**Appendix I of RNTPC Paper  
No. A/YL-MP/381**

**APPLICATION FOR PERMISSION  
UNDER SECTION 16 OF  
THE TOWN PLANNING ORDINANCE  
(CAP. 131)**

(a) Proposed use(s)/development 擬議用途/發展	擬議臨時公眾停車場（貨櫃車除外）（為期3年）和相關的填塘及填土工程 Proposed Temporary Public Vehicle Park (Excluding Container Vehicle) for a Period of 3 Years and Associated Filling of Pond and Filling of Land  (Please illustrate the details of the proposal on a layout plan) (請用平面圖說明擬議詳情)
--	--

寄件者: [REDACTED]  
寄件日期: 2025年01月09日星期四 12:05  
收件者: tpbpd/PLAND  
副本: Jane Ching Kei LAU/PLAND  
主旨: Re: 有關A/YL-MP/381 運輸署意見及公眾意見回覆  
附件: 31052 R-to-C\_TD\_20250109.pdf; MP381\_Traffic.pdf; MP381擬議發展細節及公眾意見回覆\_20250107.pdf

Figure R1

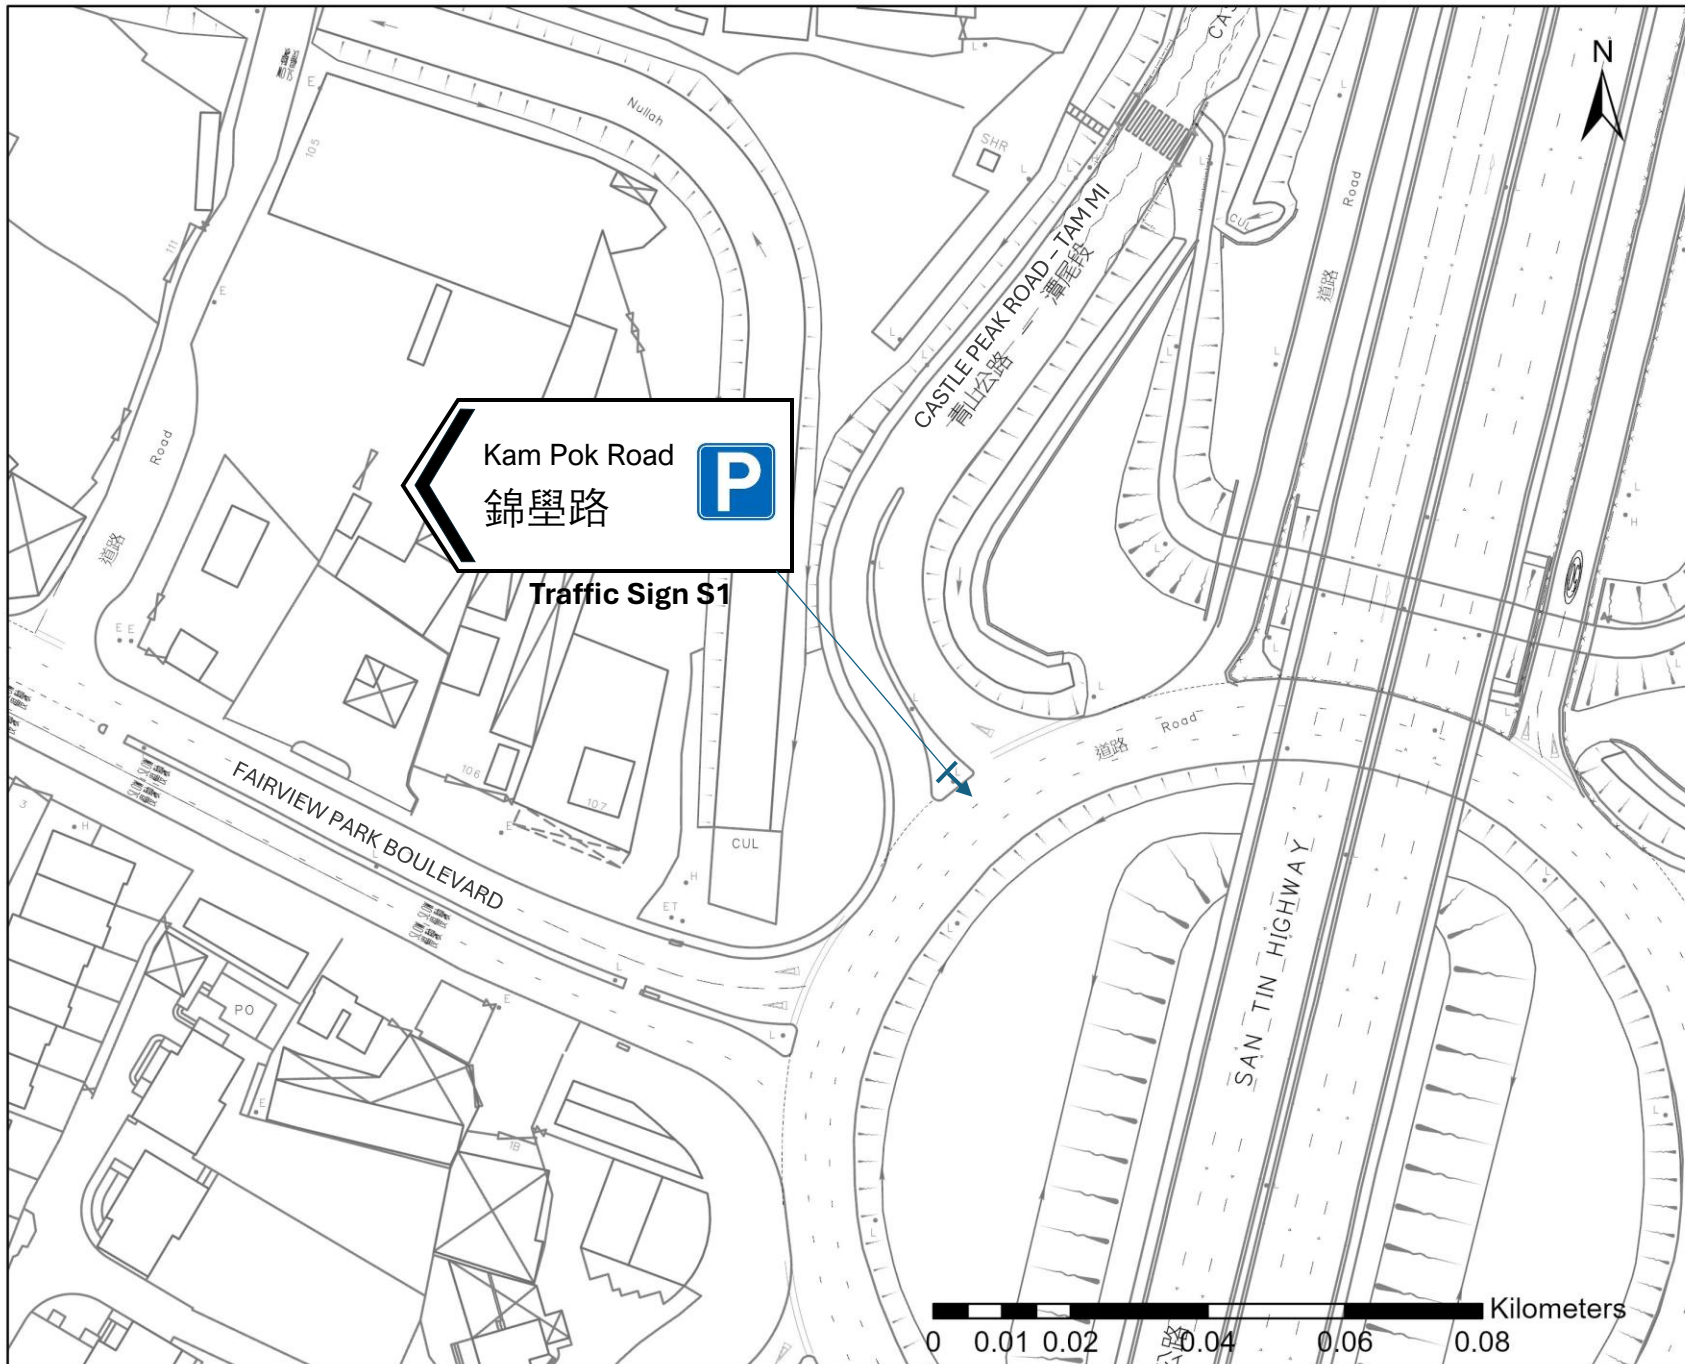
e. Noted the applicant assumes vehicles would access the subject site via Castle Peak Road - Tam Mi and Kam Pok Road. Please advise if there are any signs or measures to be provided on-site to guide motorists to follow the above-mentioned routing.	The proposed traffic sign is depicted in the attached Figure R1 and R2.

### 1.14 Traffic Management Plan

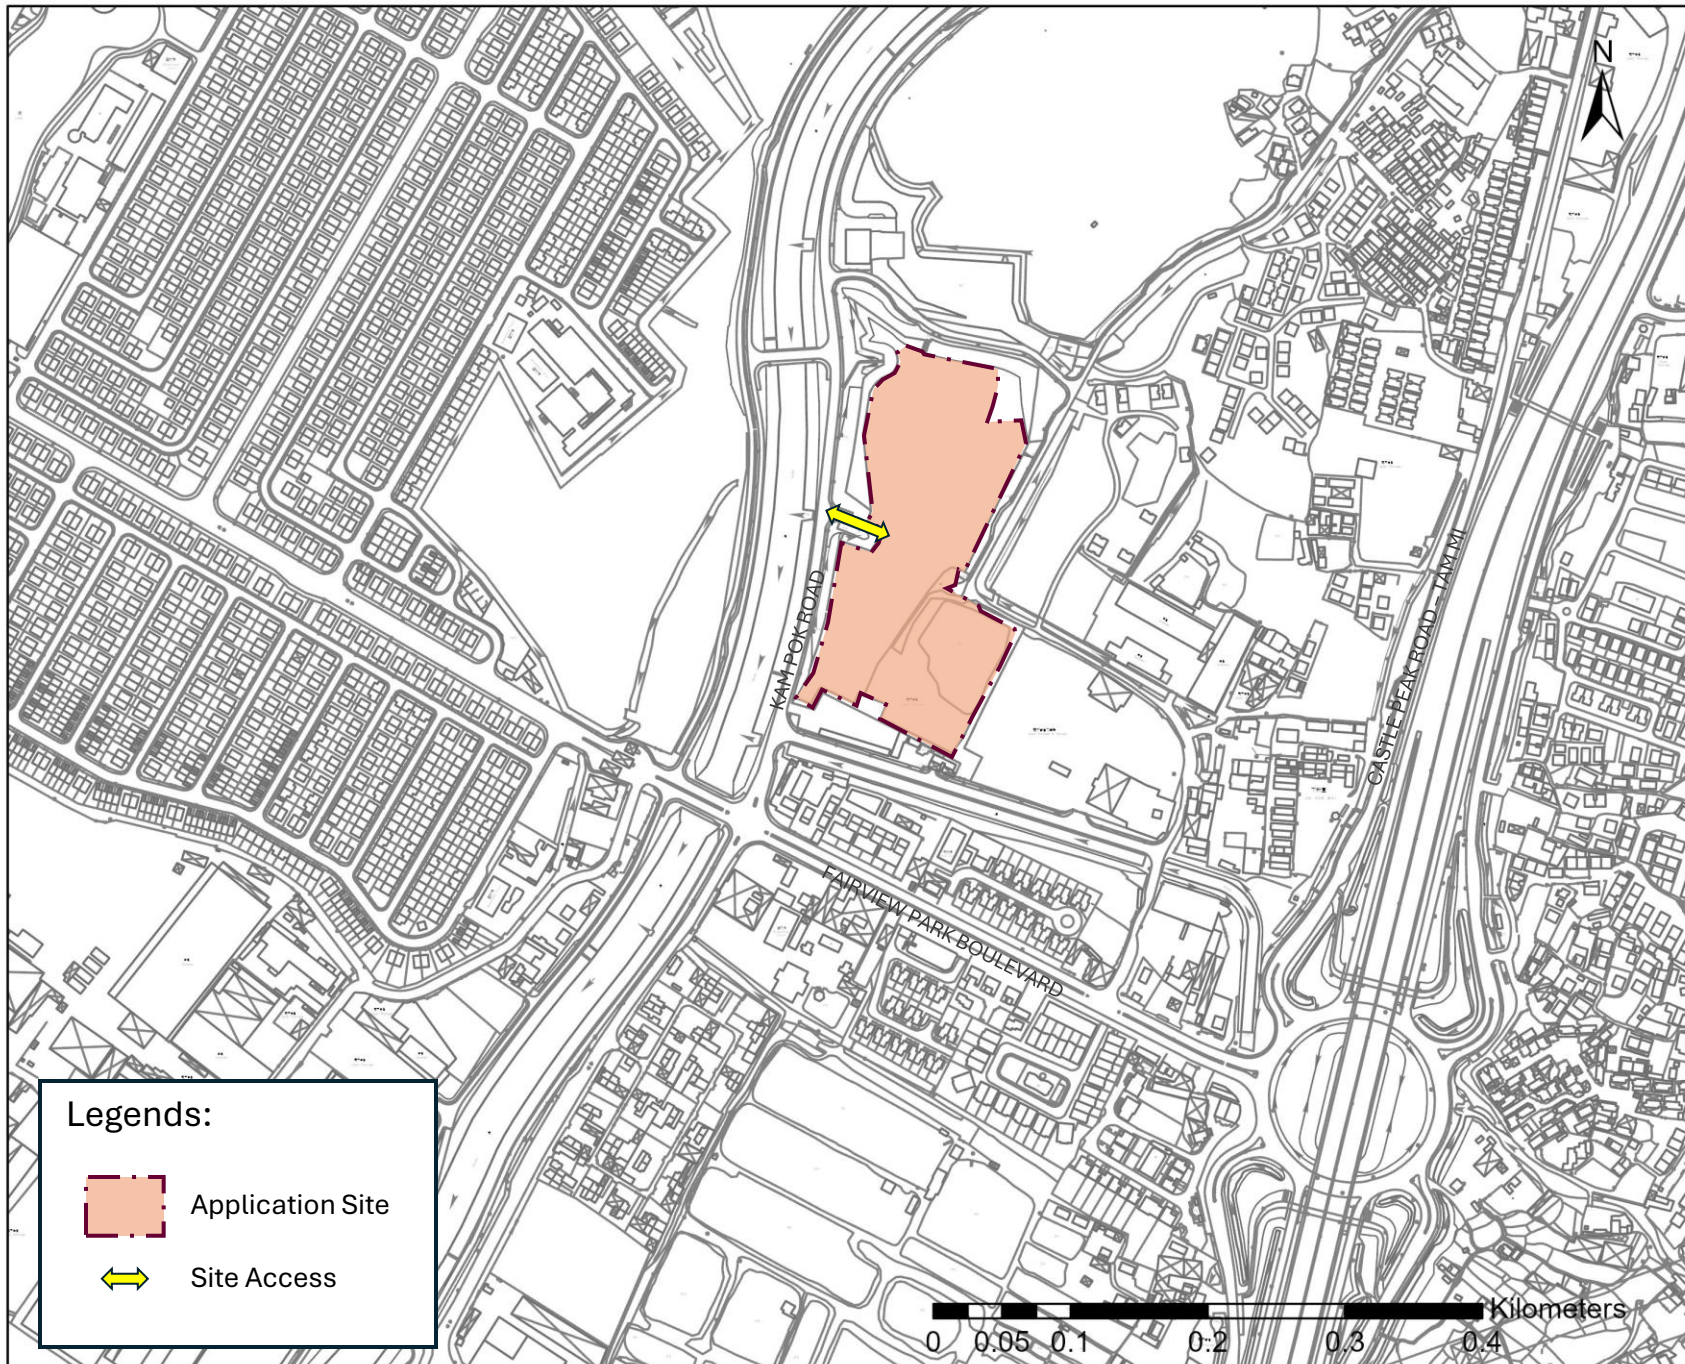
b. From the RtC, noted only 20% (~40 nos.) of the parking space in the captioned planning application are opened to public for hourly rent, it is not preferably to erect car park symbol directional sign in Fairview Park Interchange and Castle Peak Road - Tam Mi to guide the motorist to the subject site. Please rewrite para. 1.8 and update the figures in the Report.	Noted. The car park symbol directional sign will not be proposed and the para. 1.8 has been rewritten.

The parking ingress will be routed via Castle Peak Road – Tam Mi and Kam Pok Road, as Fairview Park Boulevard prohibits right turns onto Kam Pok Road. For egress, traffic signs will be installed within the site boundary to direct vehicles to turn right when exiting. The proposed sign face is illustrated below:
